Bylong Coal Project

Response to Submissions on Groundwater

Prepared for
Hansen Bailey Pty Ltd

Water table within Quaternary alluvium - north - December 2015

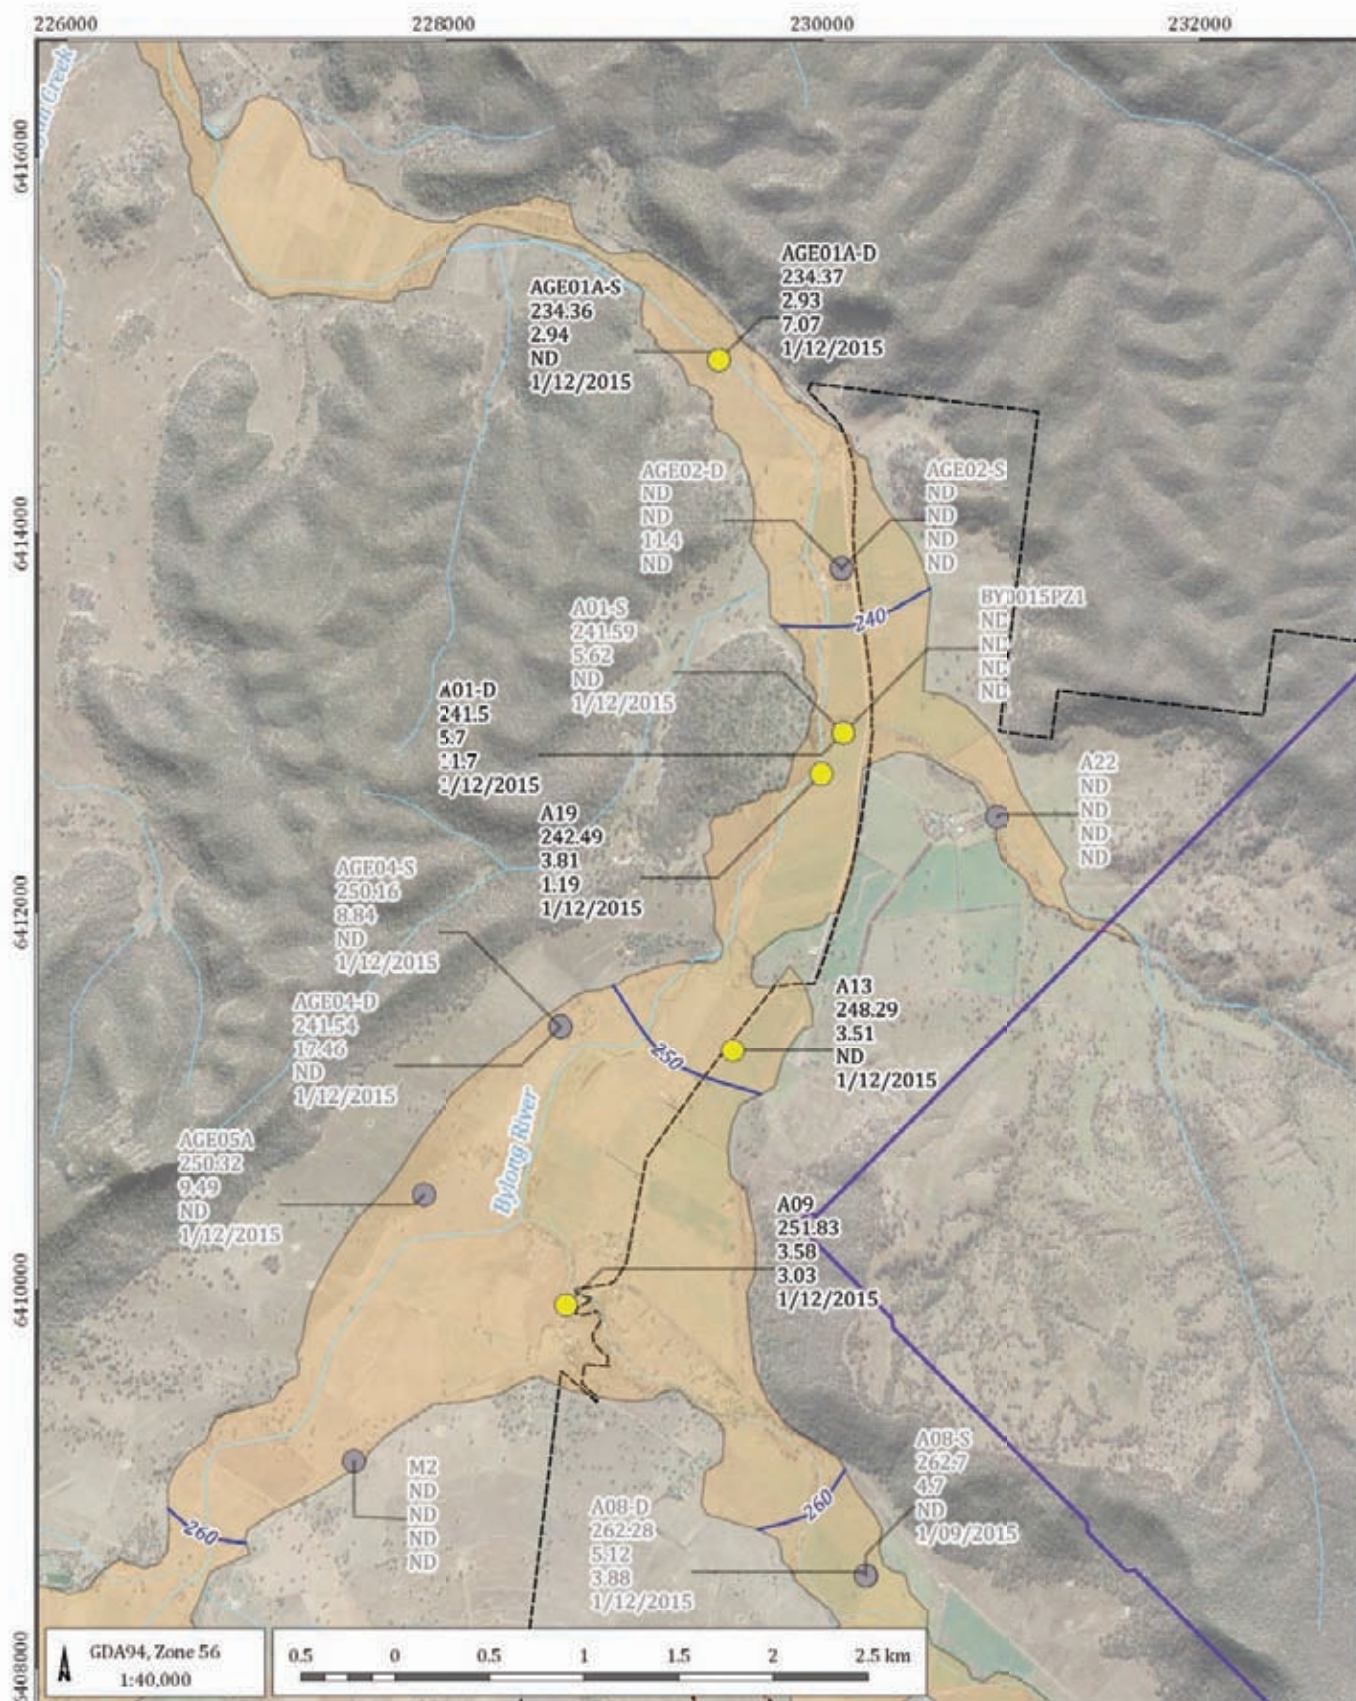
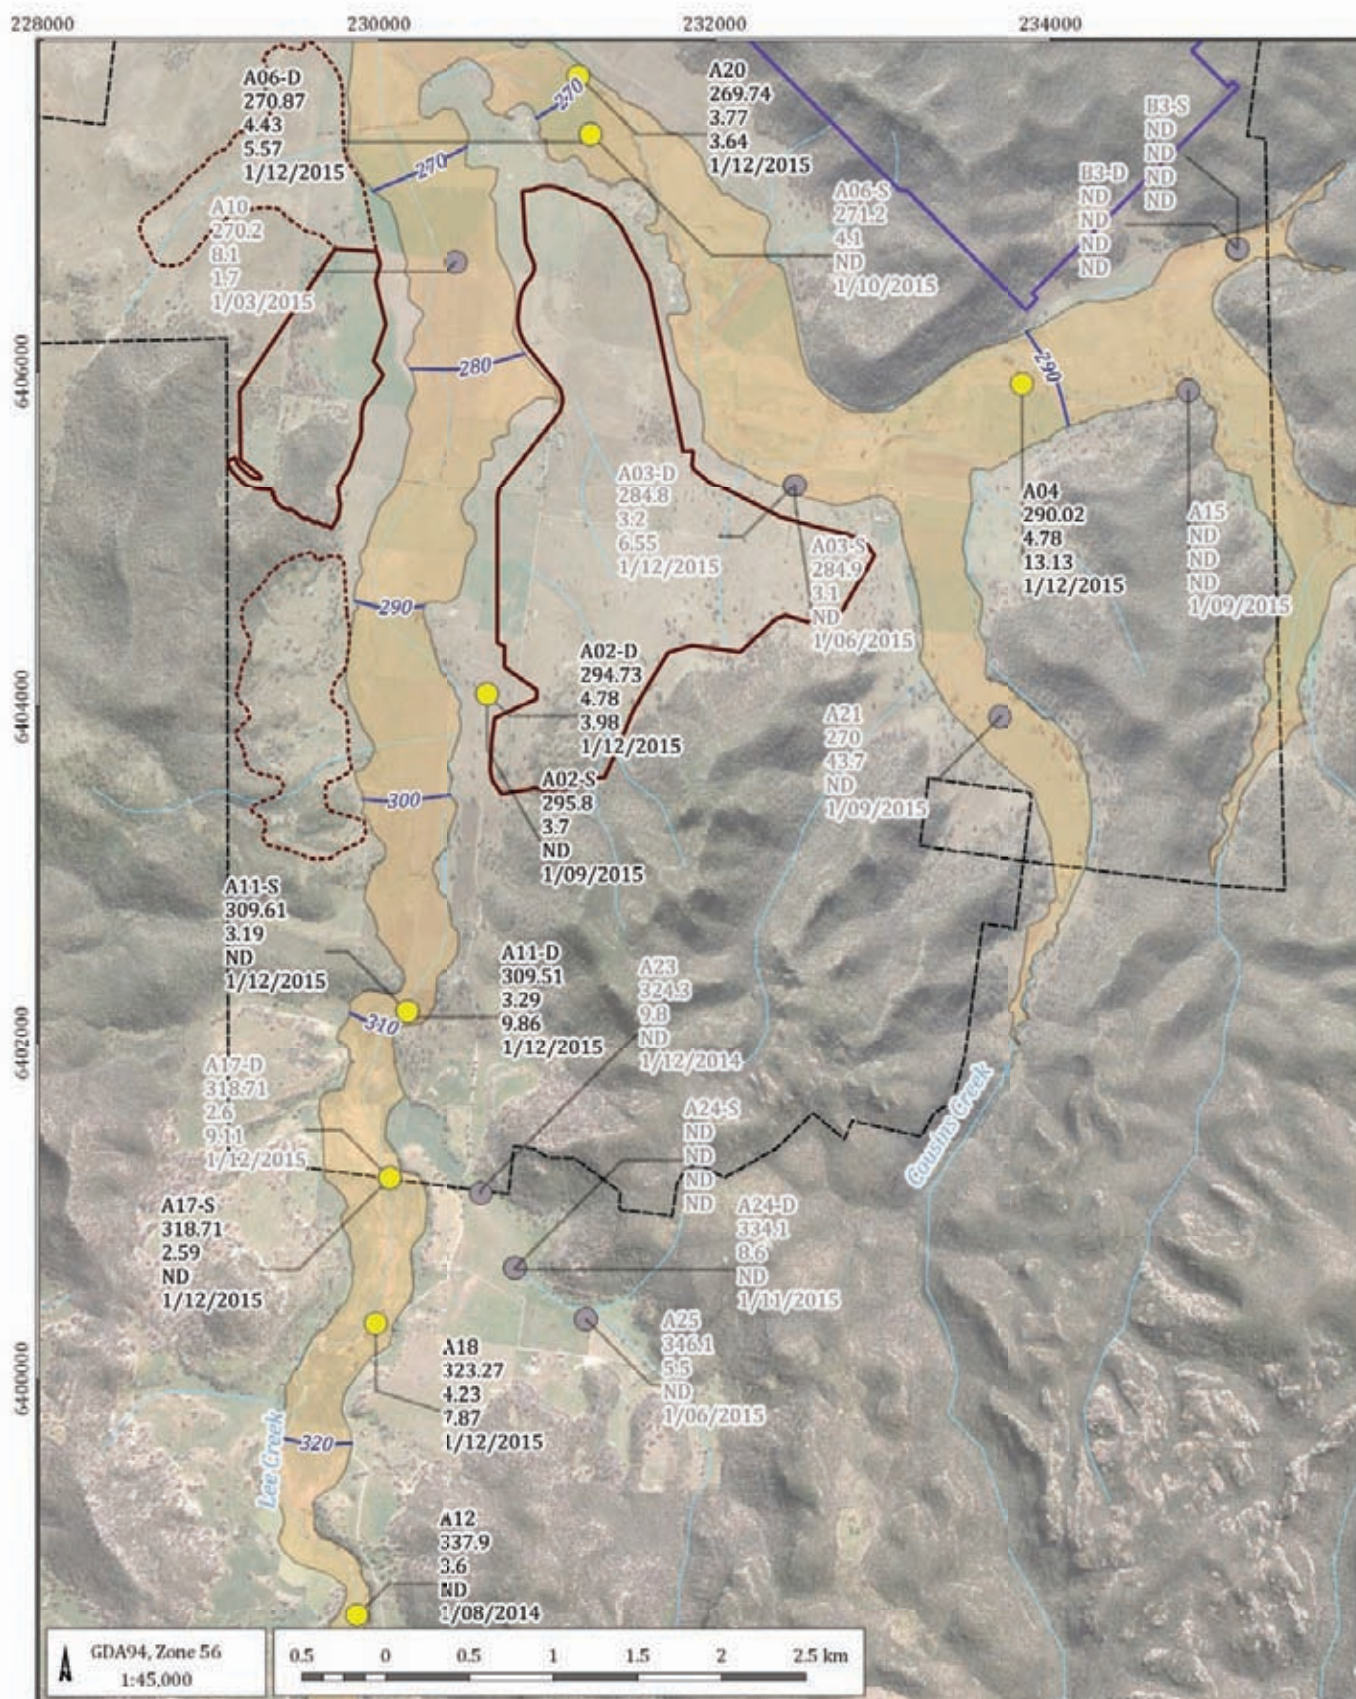
A stakeholder requested additional groundwater contour maps for each individual aquifer identified within the Project Boundary with bores labelled with a representative rest water level. KEPCO have continued to monitor groundwater levels within the alluvial groundwater systems since submission of the EIS. Figure 2 shows the locations of the monitoring bores constructed within the alluvial sediments. There is now up to four years of baseline water level data available for the Project. Appendix C contains water level hydrographs for the alluvial monitoring bores, as well water level data for the bores installed in the other geological units (a number of bores have only a single measurement of water level and therefore time trends cannot be plotted). Data collected prior to 2015 was presented within the EIS, but is reproduced along with new data collected since 2015. The water level records for each bore are plotted with the cumulative rainfall departure (CRD) using data from Wollar (Barrigan Street) recording station (Bureau of Meteorology Station Number 062032). A rising trend in the CRD indicates above average rainfall, whilst a declining trend occurs when rainfall is consistently below average. The CRD for the monitoring period indicates above average rainfall at the commencement of monitoring in late 2011/early 2012, followed by generally below average rainfall over much of the baseline monitoring. Some above average spikes in rainfall have occurred in the summer months, but overall the trend indicates a rainfall deficit in the Project Boundary during the monitoring period.

The most recent groundwater monitoring, from December 2015, has been used to develop the requested contour maps inferring the water table elevation in the alluvium of the Project Boundary. Figure 8 and Figure 9 show the inferred water table at a local scale in the northern and southern portions of the Project Boundary respectively. The same water level data has been used to plot depth to the water table from ground surface and the saturated thickness of the alluvium. In some cases, December values were not available, or were considered erroneous, and so the last recorded data point was used or in some instances none at all.

The water table elevation maps (Figure 8 and Figure 9) for the alluvium shows an inferred hydraulic gradient that broadly matches the northerly direction of surface water flow through the channel system. This fits with a conceptual understanding of the river and creek system being a surface expression of the water table in general, with localised and temporal transitions between gaining and losing conditions. The direction of groundwater flow is towards the Goulburn River, which is considered the principal discharge point for water in the alluvium. The contours indicate a moderate hydraulic gradient (~1:100) through the centre of the Project Boundary that aligns with the local topography.

Figure 8 and Figure 9 show the depth to the water table at each alluvial monitoring bore which ranges from 3 m to 5 m below surface in December 2015. As discussed above, hydrographs of the alluvium monitoring bores show this to be deeper than when monitoring first commenced due to below average rainfall.

Figure 16 Horizontal hydraulic conductivity of Coggan and Ulan Coal Seams

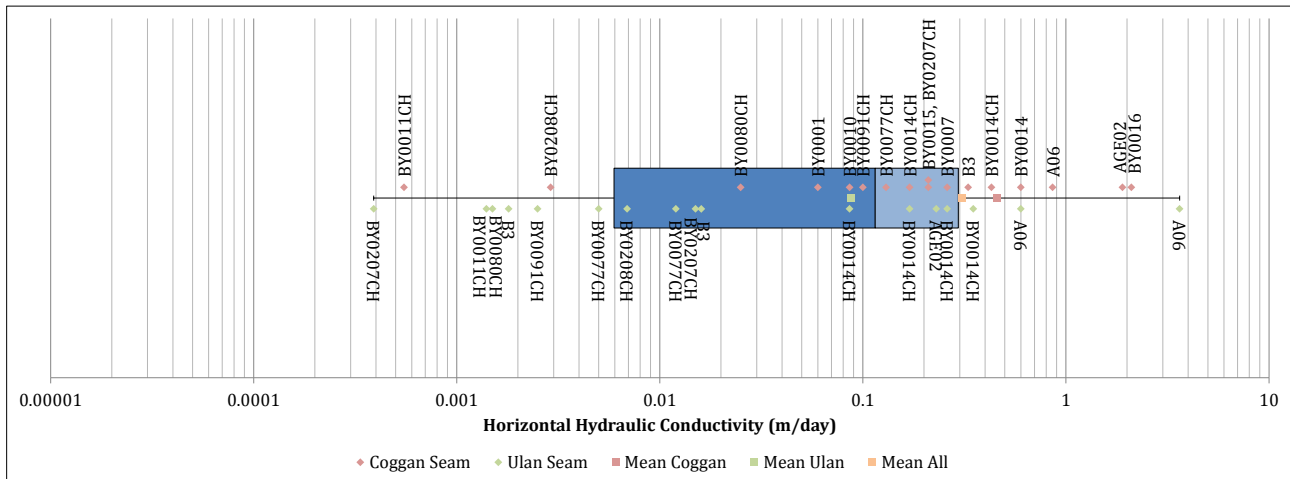
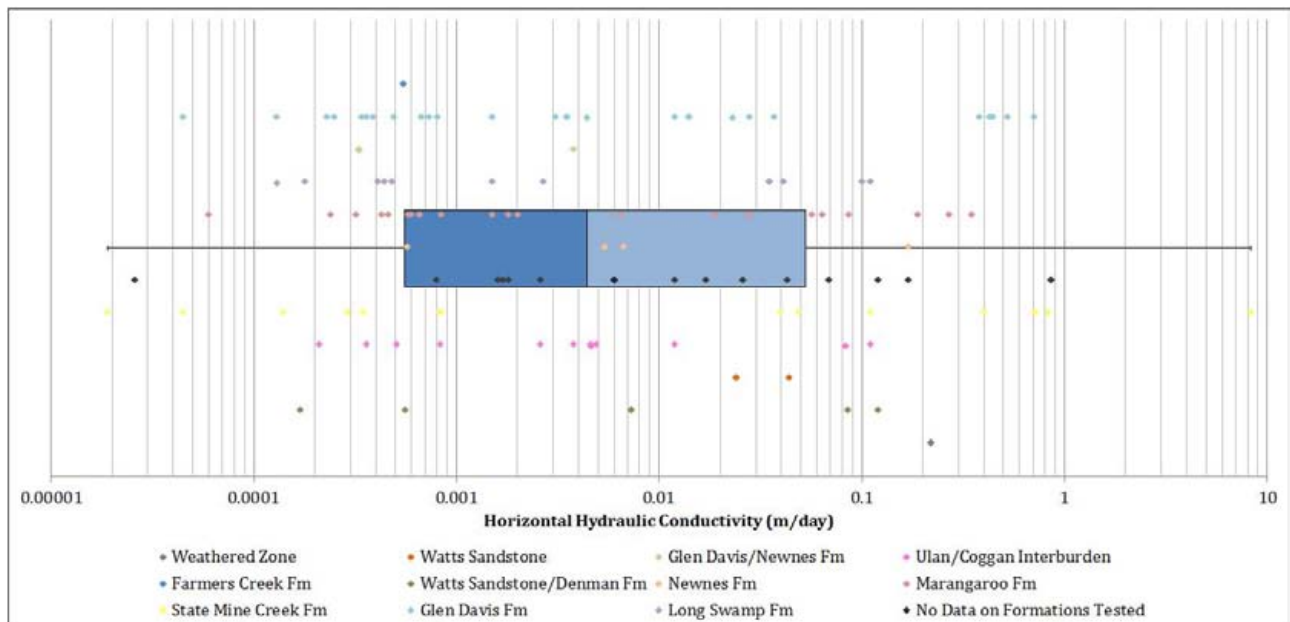
Stakeholders requested additional information on groundwater systems within the Triassic and Permian bedrock units, particularly the formations overlying the coal seams. Some stakeholders also queried the ratio of hydraulic conductivity and specific storage adopted for the modelling. The sections below provide further information on the hydrostratigraphic units within the Permian, including hydraulic properties, zone of weathering, water levels, flow directions and preferential recharge zones where the coal seams contact the alluvium.

As discussed above, the groundwater regime in the coal measures has been represented by combining geological units to create hydrostratigraphic units. This required lumping of the formations overlying the coal seams targeted for mining to create relatively thick layers with uniform properties. The approach was based on the results of hydraulic testing that indicated a generally lower hydraulic conductivity within the non-coal units (sandstones, siltstones, claystones and interbedded combinations) compared to the thicker coal seams proposed to be targeted for mining. Figure 16 and Figure 17 show the distribution of horizontal hydraulic conductivity measurements for the coal and non-coal units. It shows the typically wide range in hydraulic conductivity that is common for porous and fractured rocks, but a median hydraulic conductivity of some 60 to 70 times lower in the non-coal units compared with the coal. Figure 17 shows no clear trends in the hydraulic conductivity of the overlying non-coal formations.

Numerical model weathered zone thickness

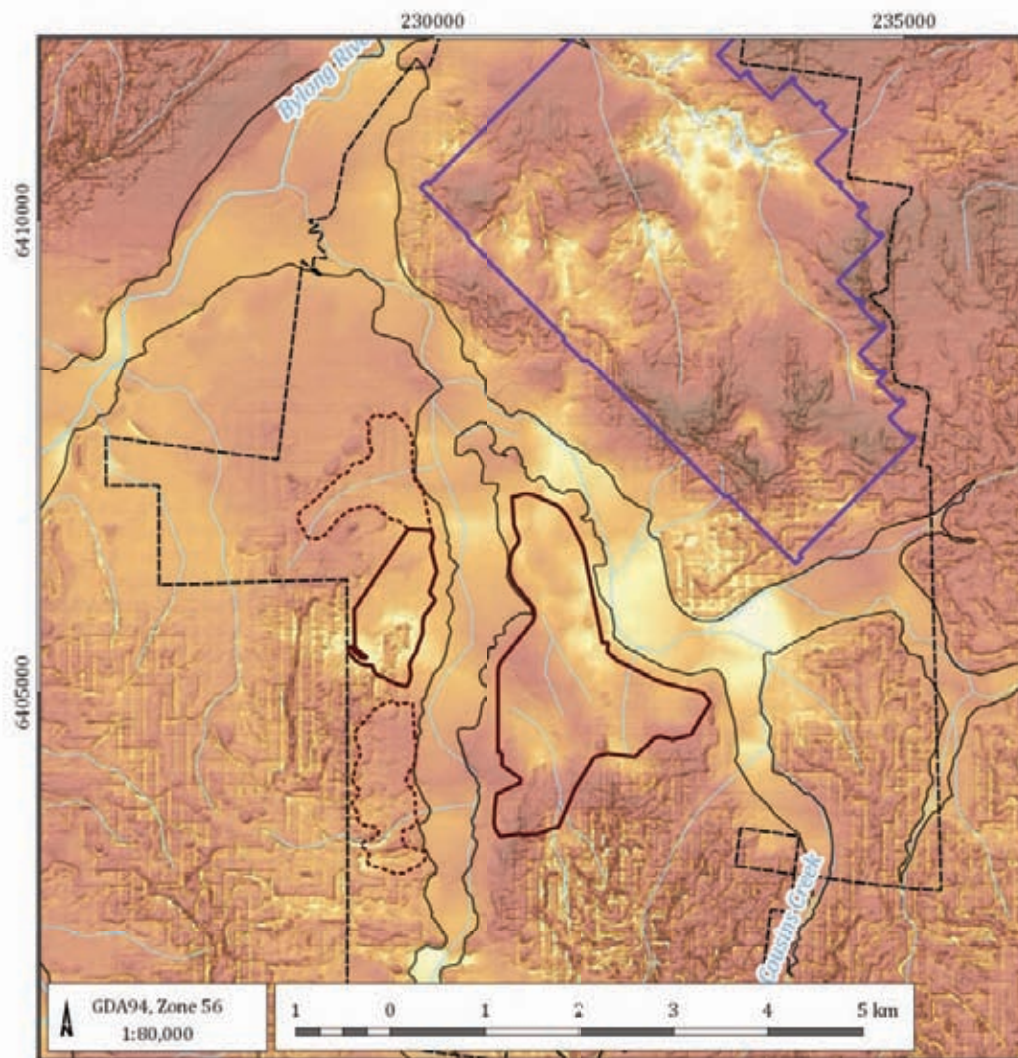
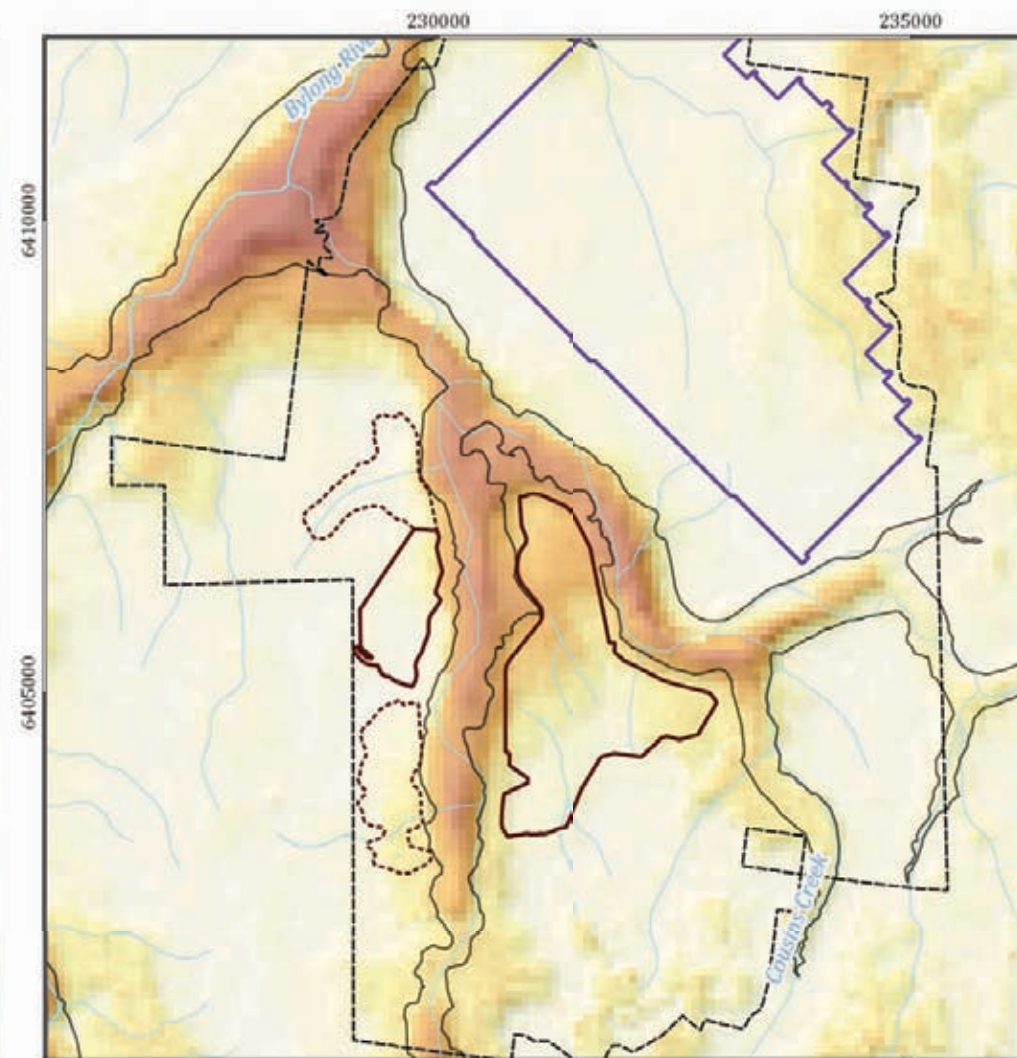
Stakeholders also requested more detail on the hydraulic properties of the weathered zone and a map indicating the thickness of the unit. Figure 17 above shows the hydraulic conductivity values measured within weathered rock units, indicating a wide range from between 0.0001 m/day and 1 m/day. Figure 18 shows the thickness of the weathered zone represented within the numerical model developed for the EIS. Figure 18 also shows analysis from CSIRO (2015) estimating the thickness of regolith material from remote sensing analysis. Regolith is a layer of loose, heterogeneous superficial material covering solid rock.

The available data indicates hydraulic properties of the weathered zone vary considerably. Given the natural variability that occurs within the weathered zone, it was important in the EIS to adopt conservative hydraulic properties that would ensure the maximum impact was identified. The weathered formations in elevated areas outside the floodplain are largely unsaturated. In contrast, in areas of the lower lying valley floors, the weathered zone rock that is adjacent to and underlies the alluvium is likely to be saturated for most periods of time. This is of particular interest in the region between the proposed open pits and the flood plain where the weathered zone may yield groundwater to the open pits during mining and act as a conduit for flow through from the alluvium. For this reason, the EIS conservatively adopted a horizontal hydraulic conductivity value for the weathered material of 0.2 m/day, at the extreme of the available data to ensure the impacts of connecting the mining and the alluvium through the weathered zone were represented.

The potential for the weathered zone to enhance connectivity with the underground mining areas only occurs in the low lying flood plain areas, as available data from VWP's indicates the thin weathered zone is unsaturated in the elevated areas.
